3.3.2—Load and Load Definitions

3.4.1—Load Factors and Load Factor Combinations

Figure 3.6.1.4.1-2 Fatigue Permit Truck

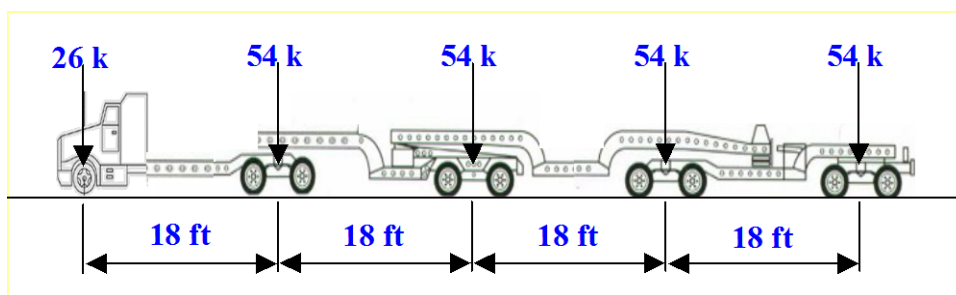
Fatigue Permit Truck specified in 3.6.1.4.1-2 represents the majority of permit trucks allowed in California.

For the Fatigue II limit state, the fatigue load shall be one Permit truck as specified in Figure 3.6.1.4.1-2 and Figure 3.6.1.4.1-3.

Figure 3.6.1.8.1-1—California P15 truck

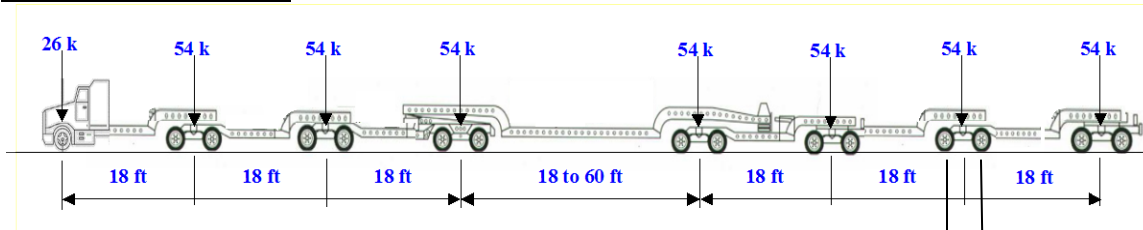
Add Article 3.6.1.8 as follows:

The weights and spacings of axles and wheels for the overload truck shall be as specified in Figures 3.6.1.8.1-1 and 3.6.1.8.1-2.
